# City of Portland Historic Landmarks Commission

## Design Advice Request #3

### SUMMARY MEMO

**Re:** EA 22-184037 DA – Jefferson High School Development  
Design Advice Request #3 Commission Summary Memo – November 20, 2023

Current

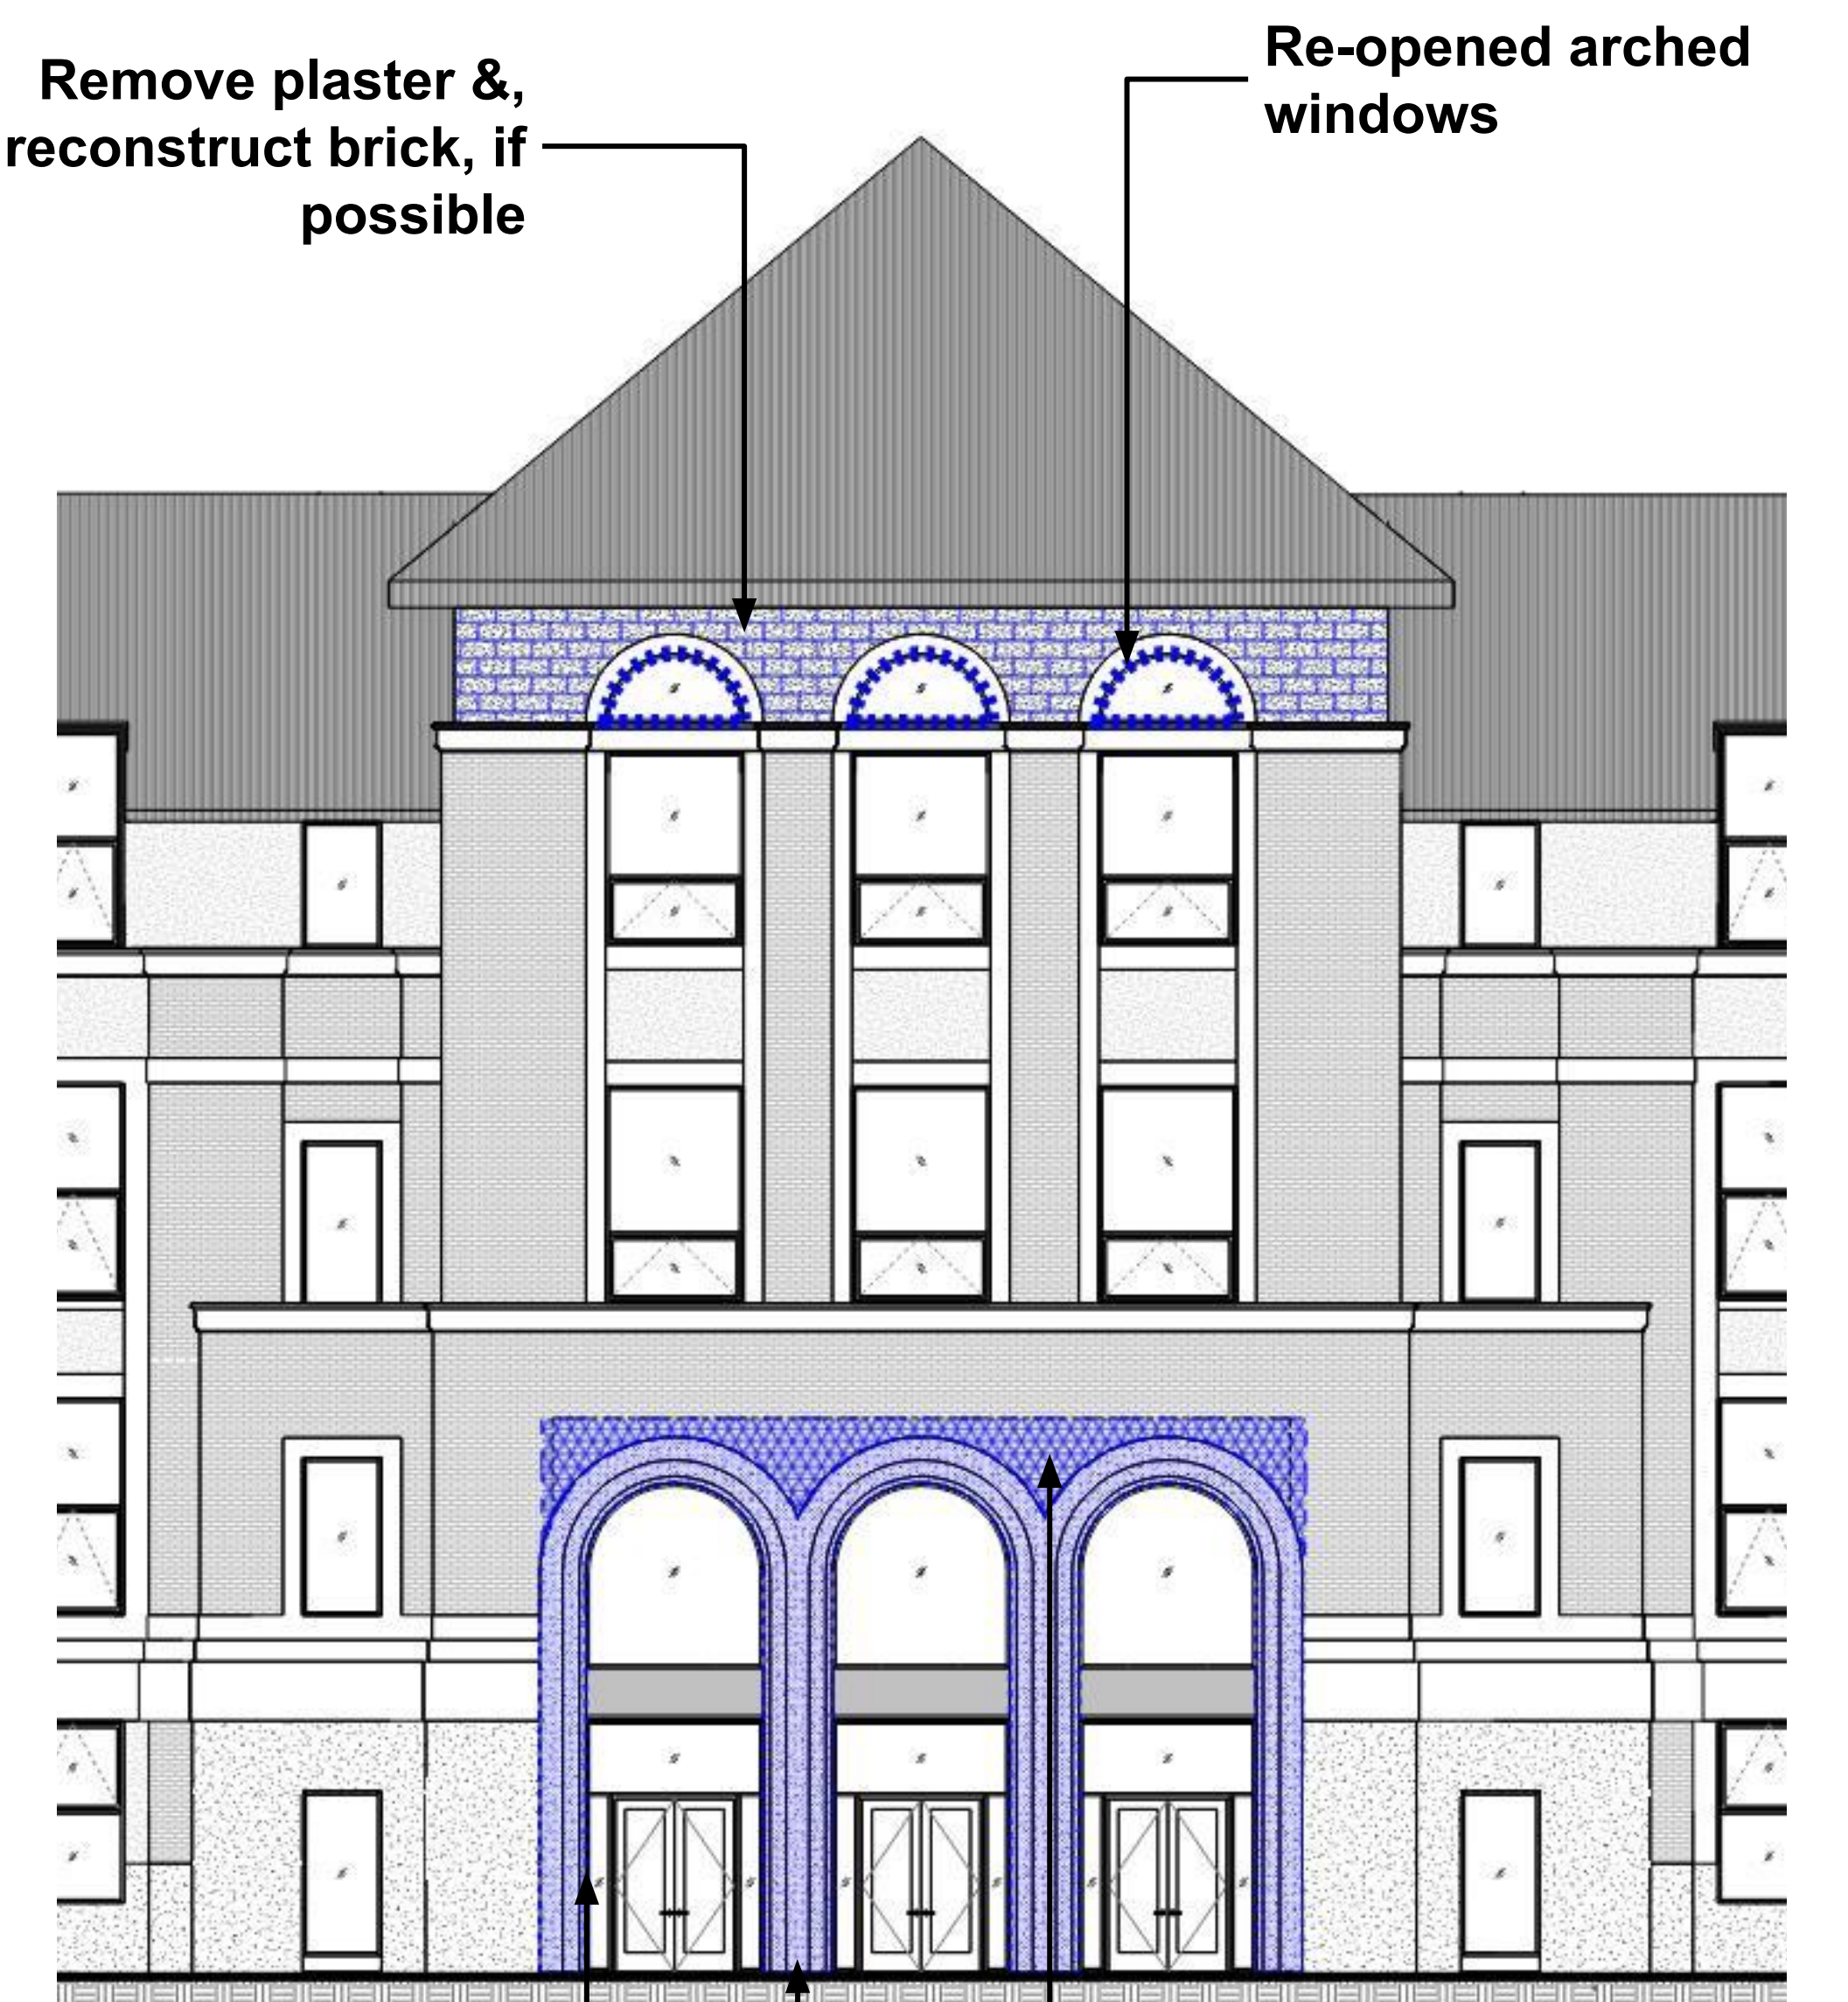
- Commissioners supported the proposed removal of the berm at the north elevation and subsequent alterations to the north elevation's ground floor and at-grade entrance. Commissioners advised the team to make the area inviting and shaded so people will feel free to go through the area.

- Commissioners questioned the need for altering both of the existing east and west entrances on the 1909 building when new accessible entrances are proposed in the new portions of the building.

Remove plaster &, reconstruct brick, if possible

# 2. Recreate Central Hipped Roof Original 1909 & Current

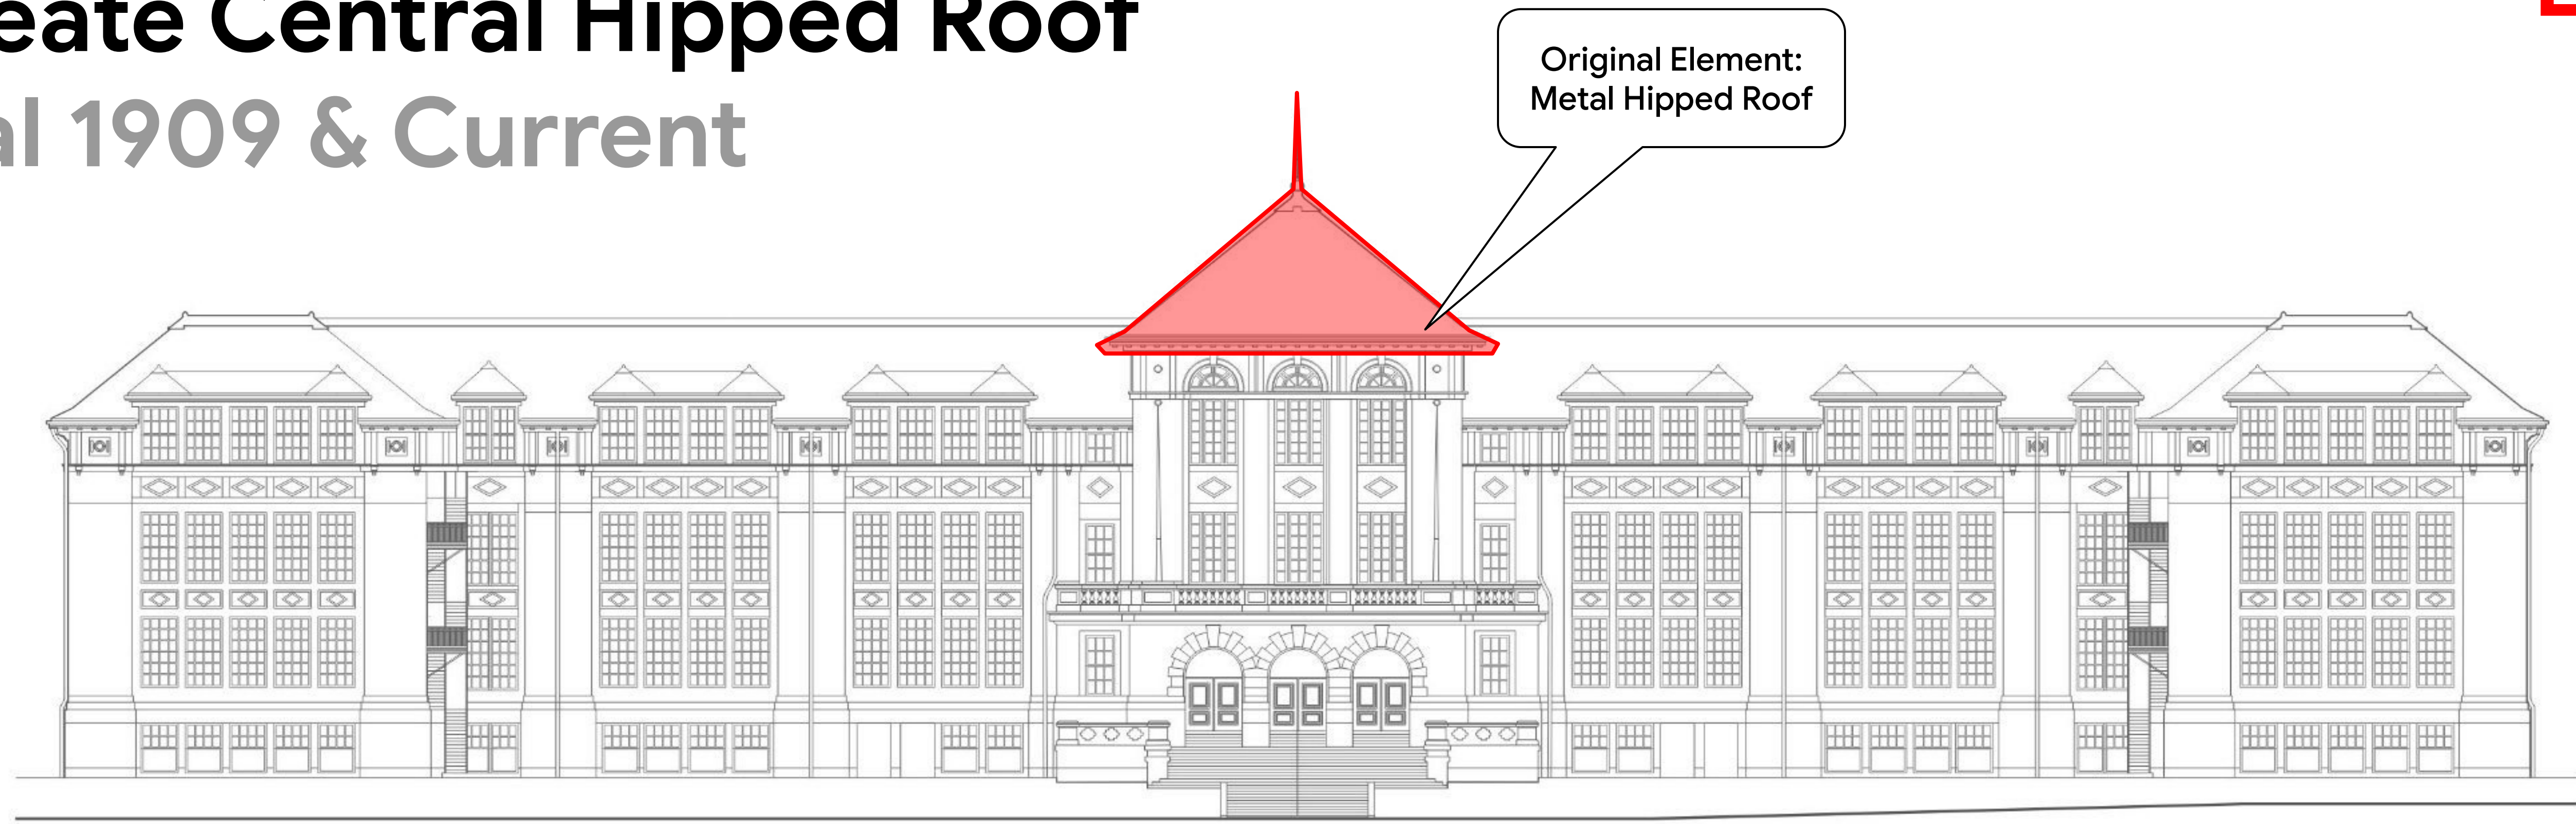
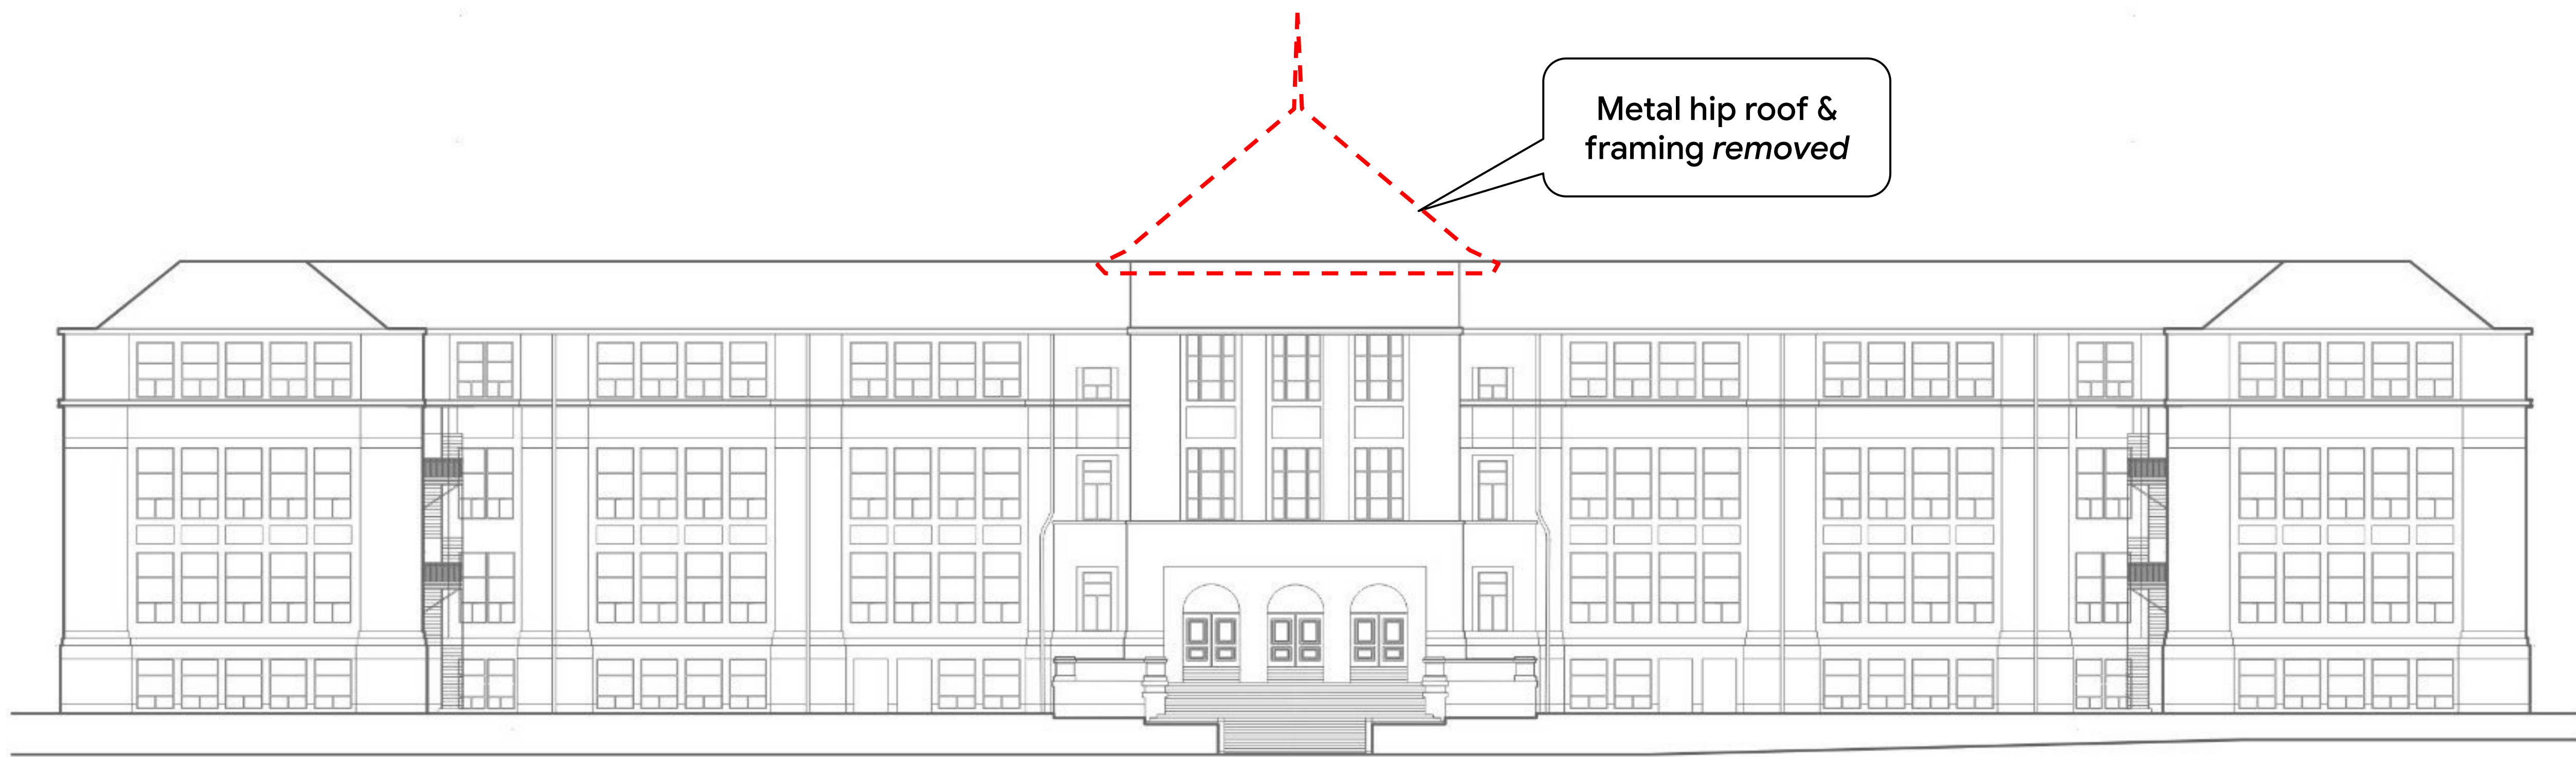
- Commissioners understood and could support the removal of the 1928 building with the condition that additional restoration measures be made to the 1909 building. These measures included but were not limited to the restoration of roof, eaves, tripartite arches and arched windows at entrances and beneath the restored roofs, and restoration of brick relief/articulation and diamond detailing.
